***USGS Review Comments Regarding the Hydraulic Models Used for the
Appeal Resolution for Congaree River in Richland and Lexington
Counties, SC***

The FEMA document above was reviewed by Janice M. Fulford (Office of Surface Water) and Larry R. Bohman (Southeastern Region) of the U.S. Geological Survey for technical/editorial clarity and accuracy. The following comments are submitted to the National Park Service for their consideration:

Figure A. – Graph of elevations used by FEMA and USGS for the downstream boundary of the two-dimensional flow models for the Congaree River.

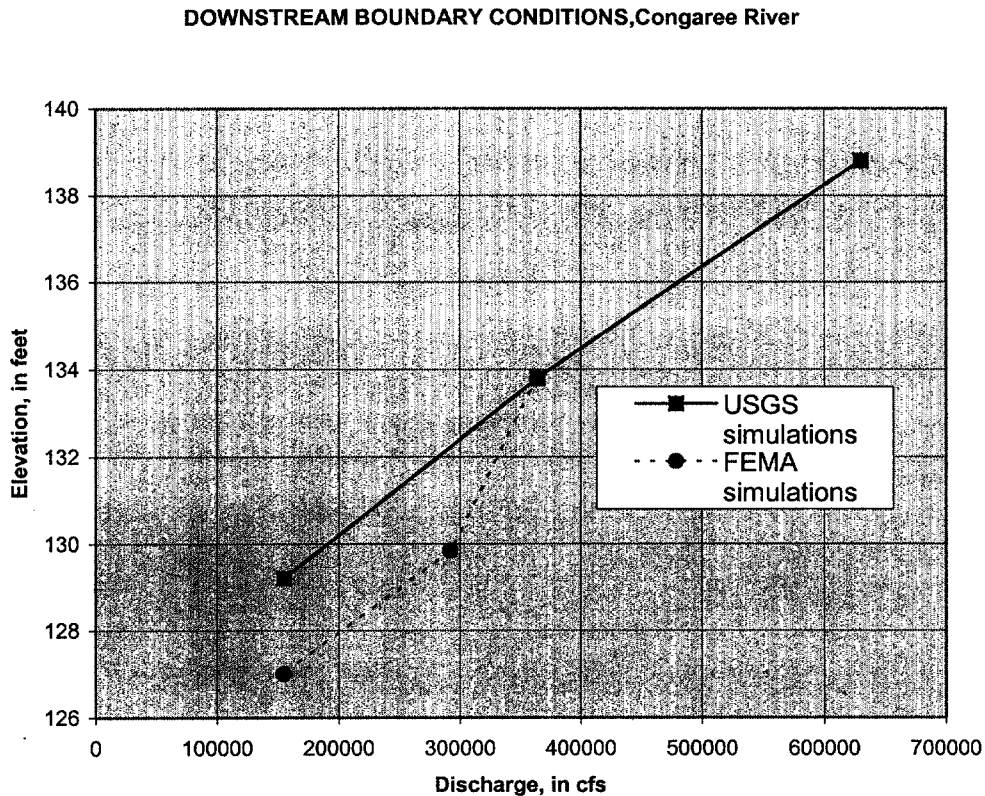
1. The downstream water surface elevations (boundary condition) used for the 1976 flood calibration of the RMA2 model and for the one percent probability flood simulations appear to be in error. The last two sentences on page 17 of the FEMA report indicate that an elevation of 129 feet was used in previous USGS modeling of the 1976 flood because model limitations at the time precluded a convergent model using an elevation of 127 feet. Neither the 1981 USGS report (OFR 81-1184, Lee and Bennett) nor the 1990 USGS report (WRIR 90-4056, Schuck-Kolben and Benedict) makes reference to any problems with model convergence. An observed elevation of 127 feet for the 1976 flood was indeed measured at a staff gage on the Congaree River near Cayce (station no. 02-169603). This gage is located at the Eastman Kodak Company plant nearly 2 miles downstream of the two-dimensional model boundary. When a flood of 155,000 cfs at an elevation of 127 feet is projected upstream from sta. 02-169603 using a one-dimensional step backwater model, an elevation of 129.2 ft is obtained at the two-dimensional model boundary. All the water-surface elevations used in the USGS modeling studies at the exit flow boundary were computed by routing each simulated flow (155,000 cfs, 364,000 cfs, and 630,000 cfs) upstream from sta. 02-169603 to the downstream boundary of the RMA2 model using a one-dimensional steady flow model. As can be seen in the graph of flows and downstream water-surface elevations used in the USGS and FEMA studies (figure A, below), the elevations used in the FEMA document study for simulated flows of 155,000 cfs and 292,000 cfs are nearly 2 feet lower than they should have been.

Figure B.-- Water elevation differences for simulation of 1976 flood between a downstream flow boundary of 127.0ft and 129.2ft

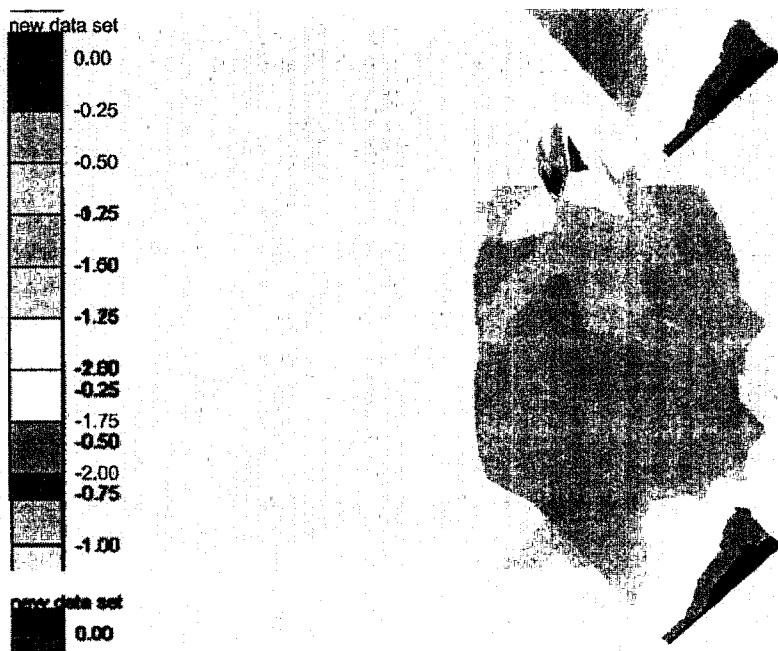
2. The verification of the RMA2 model for Lexington County for the 1976 flood was run using 129.2 ft at the downstream flow boundary. Using higher water-surface elevations at the downstream flow boundary generally result in the RMA2 model computing higher water surfaces. The differences between the measured water-surface elevations and the modeled water-surface elevations for a downstream elevation of 129.2 ft are similar in magnitude to the differences computed using the results computed with 127.0 ft. Table A below lists the differences with the measured values. Figure B shows the difference between the water surface computed for the 127.0-ft and 129.2-ft boundary elevations. The largest differences in computed water-surface elevations are near the downstream flow boundary. A careful calibration of the roughness values for the Lexington County RMA2 model for the 1976 flood would likely result in a better fit of the measured data. Because the RMA2 runs for the one percent flood and the 1908 flood are based on the verification results and because the HEC2 model is calibrated using the RMA2 results, all of the RMA2 and HEC2 results will be affected by any changes made to the Lexington County verification RMA2 model of the 1976 flood.

Figure D.-- Water-surface elevations computed for a very large breach of the dike in the northern end of the Manning's dike using a downstream flow boundary of 131.84 and a discharge of 292,000 cfs.

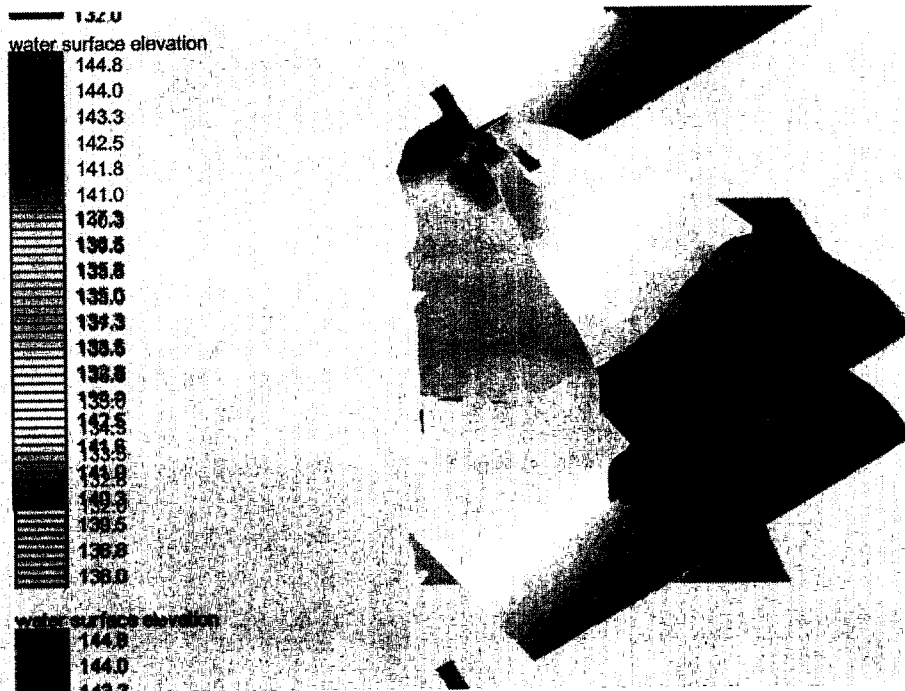
4. We concur that if breaching or overtopping of the Manning Dike occurs, that significant flow will take place on the Richland County side of the dike. As part of our review, the RMA2 model mesh was modified for a very large failure of the dike in the north section of the levee. This run supported the FEMA report conclusion that a significant portion of the one percent flood flow will take place on the Richland County side of the dike. Water-surface elevations computed using the modified mesh are shown in figure D below.
